LiDAR Quality Assessment Report

MO_RayCo_2011

Missouri Grand Ray/Jackson Cos.

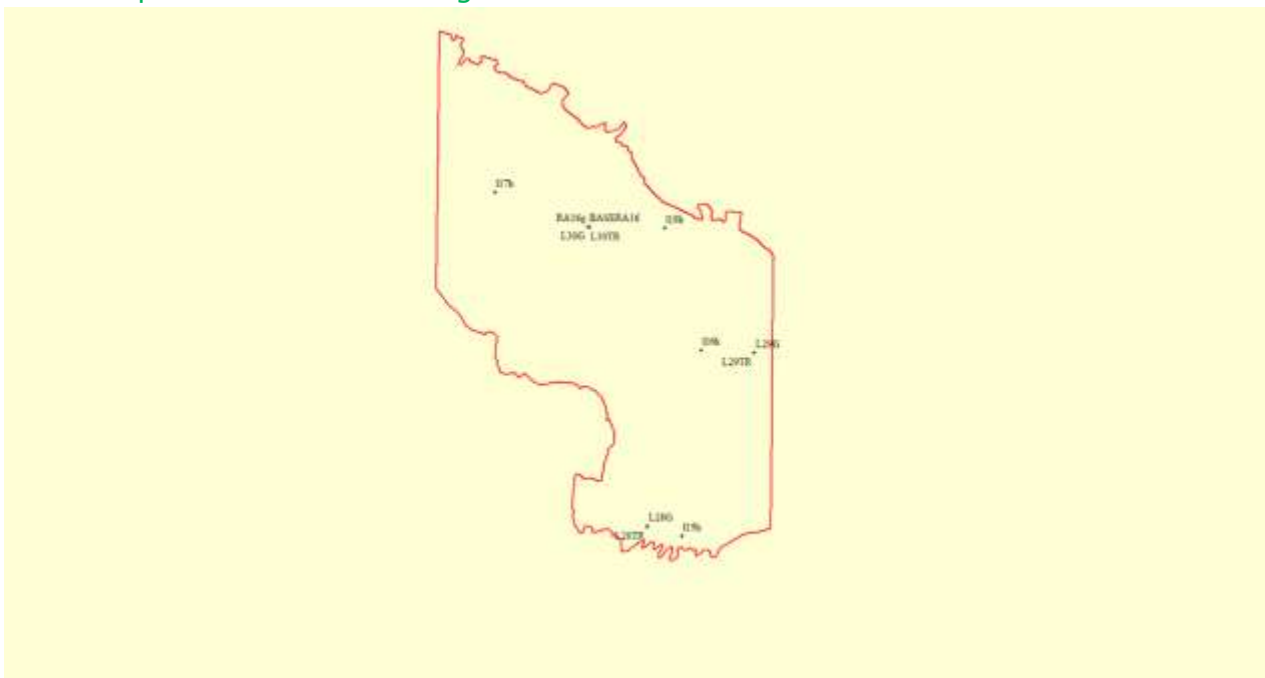
NGTOC Tested Swath FVA at 14.8cm @ 95% CI

In the Project Overview section, pg. 2 of 5, of the "LiDAR Acquisition Processing Summary" the table shown above specifies parameters used in preparing the flight plan for Ray Co. Field of View (FOV) of 34 degrees. The Min (SAMN) and Max (SAMX) Scan Angle should not exceed + or - 17 degrees from Nadir. Scan Angles exceed these parameters. The scan angles reported in LP360, -22 and 20, do not exceed Leica ALS- 50 II system accuracy limits of 75 degrees (FOV) + or -

37.5 degrees from Nadir.

Note Flying altitude is always referred to as Above Ground Level (AGL) not Above Mean Sea Level (AMSL)
